CITY OF ALBUQUERQUE

Re: Champion Xpress Car Wash
9640 Universe Blvd NW
Traffic Circulation Layout
Engineer's Stamp 05-05-2022 (B10-D003J)

Sheet:
TRAFFIC CIRCULATION LAYOUT PLAN

Sheet No.:
C-2.0

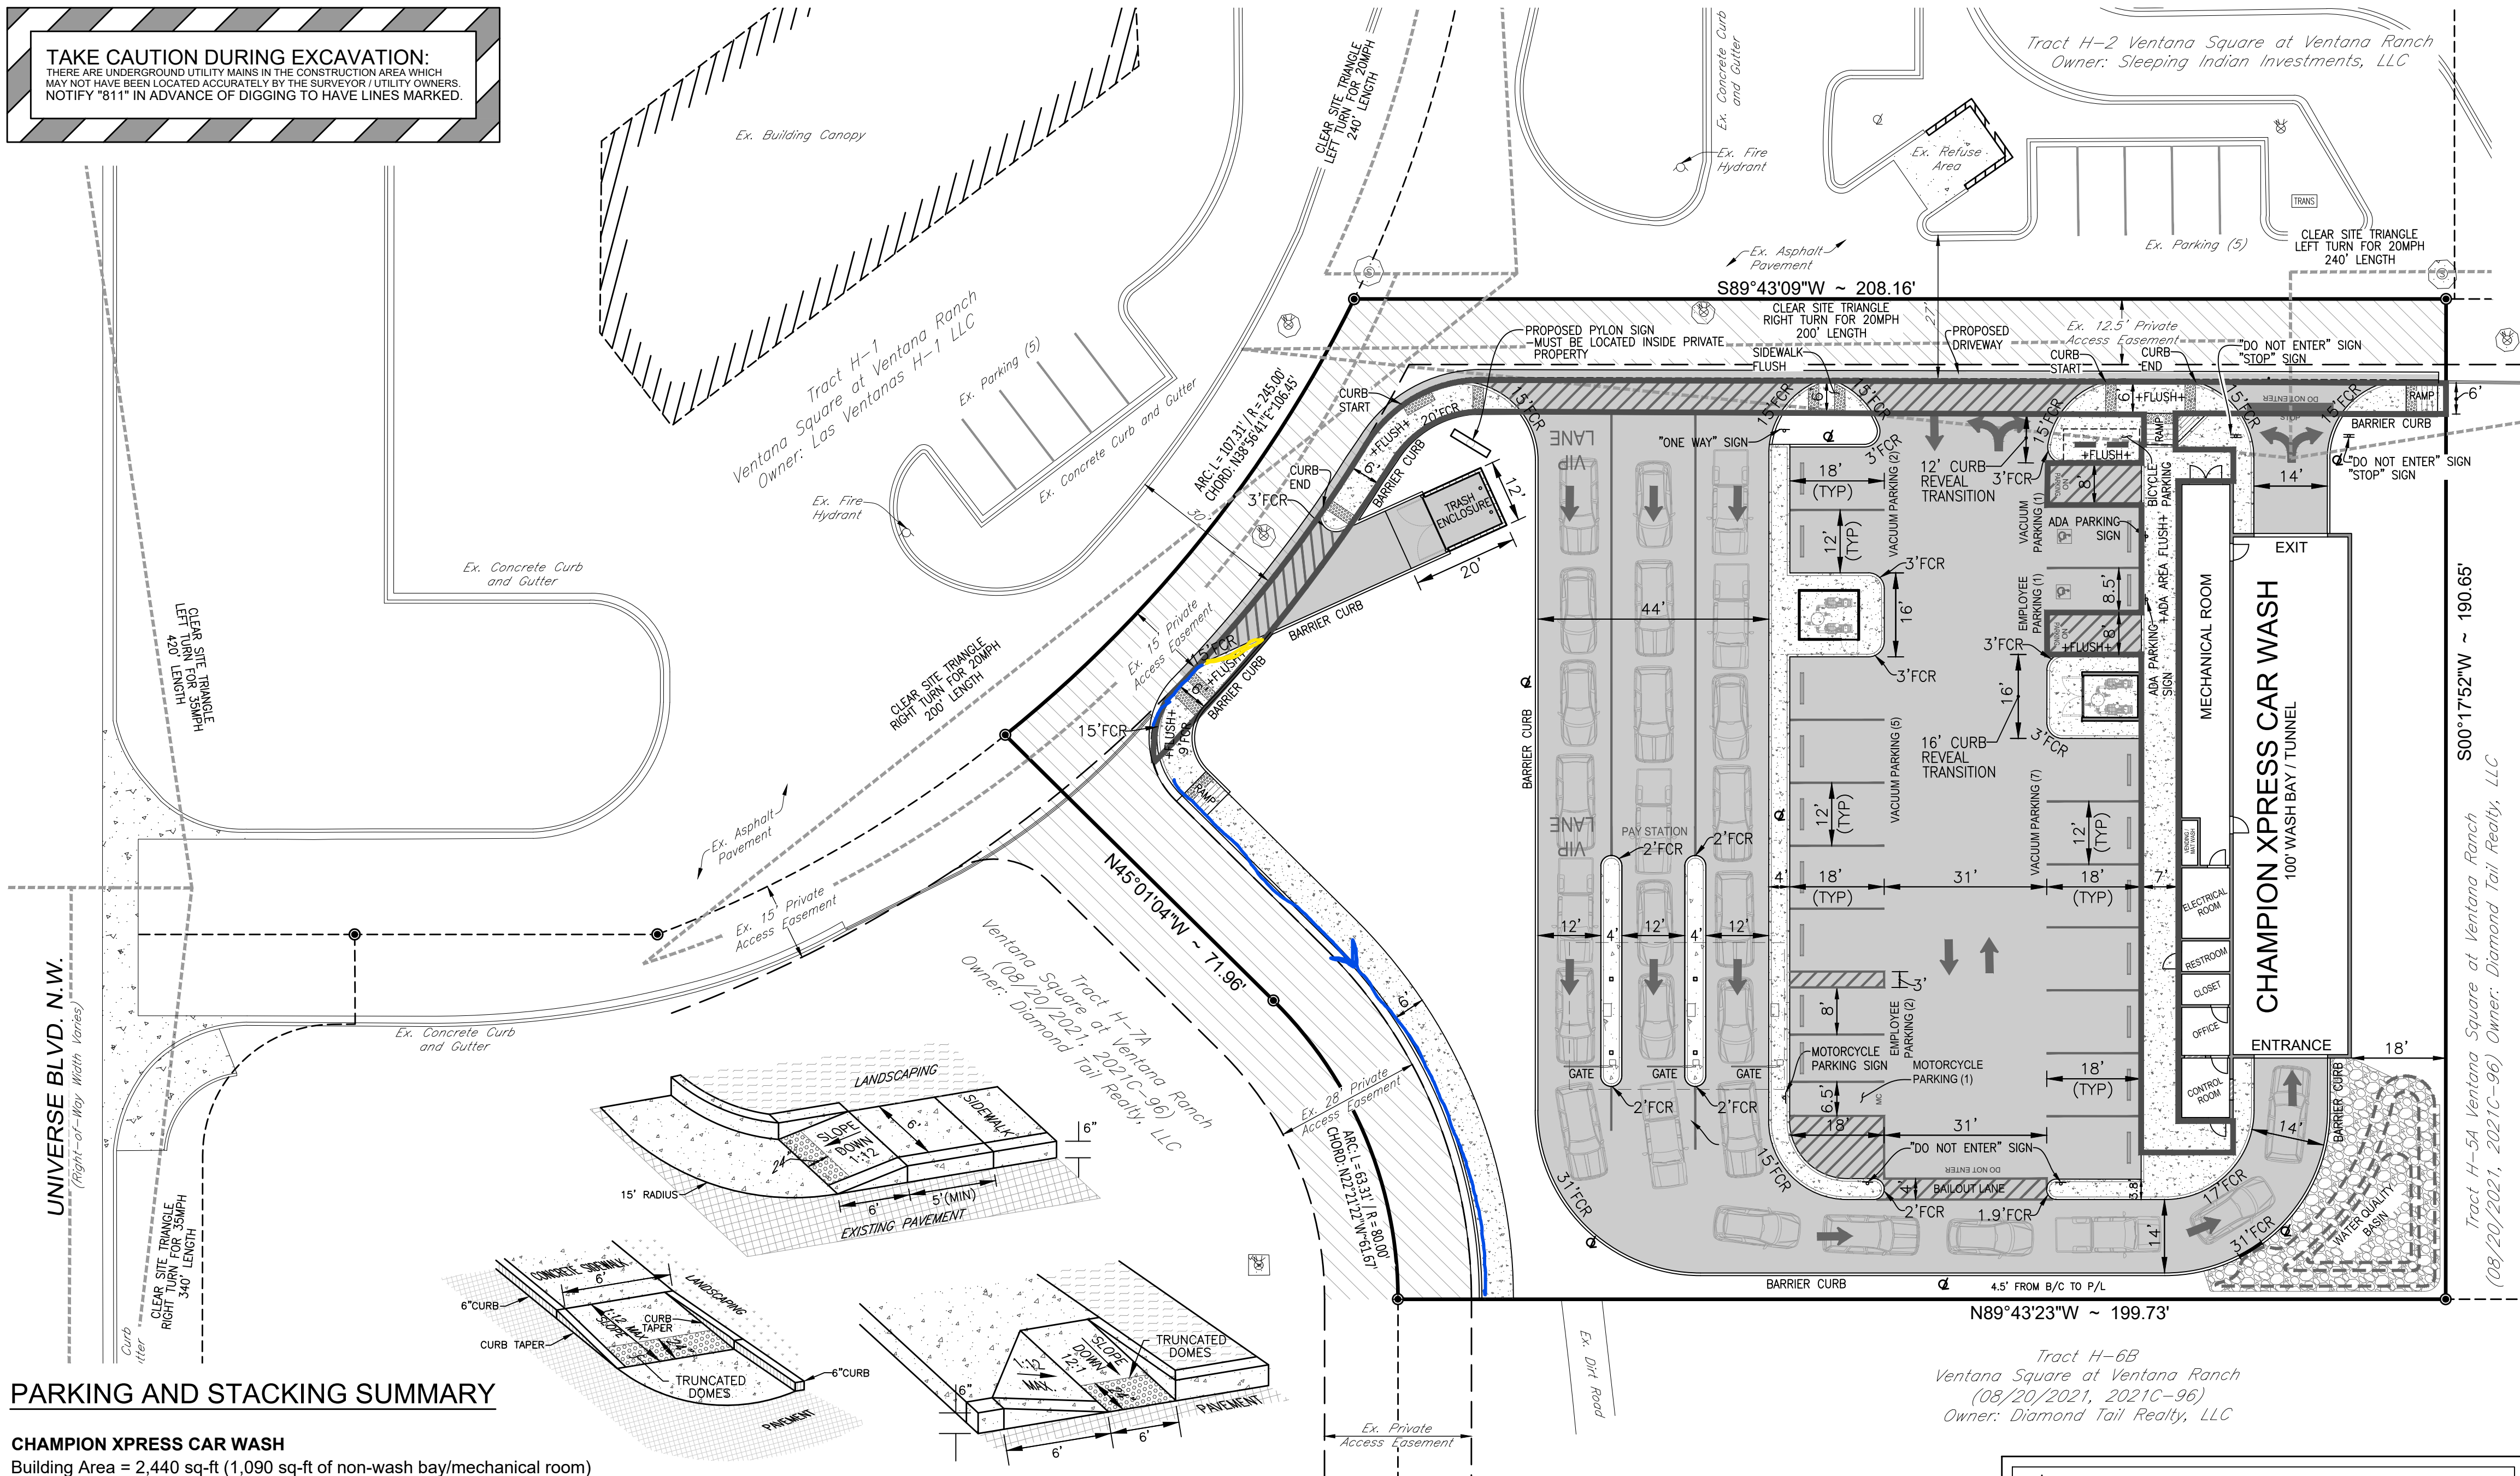
1. Call out COA std dwg 2430 for he proposed Sidewalk at the West of the site.
2. Please see attached and provide a curb when it shows blue. Remove the curb when it shows yellow at the North West of the site. For pedestrian safety issue.
3. Refuse vehicle maneuvering shall be contained on-site. The refuse vehicle shall not back into the public right of way. provide a copy of refuse approval.
4. Provide a copy of Fire Marshal Approval.
5. A copy of receipt for Resubmittal fees paid will need to be provided.
6. Please provide a letter of response for all comments given.
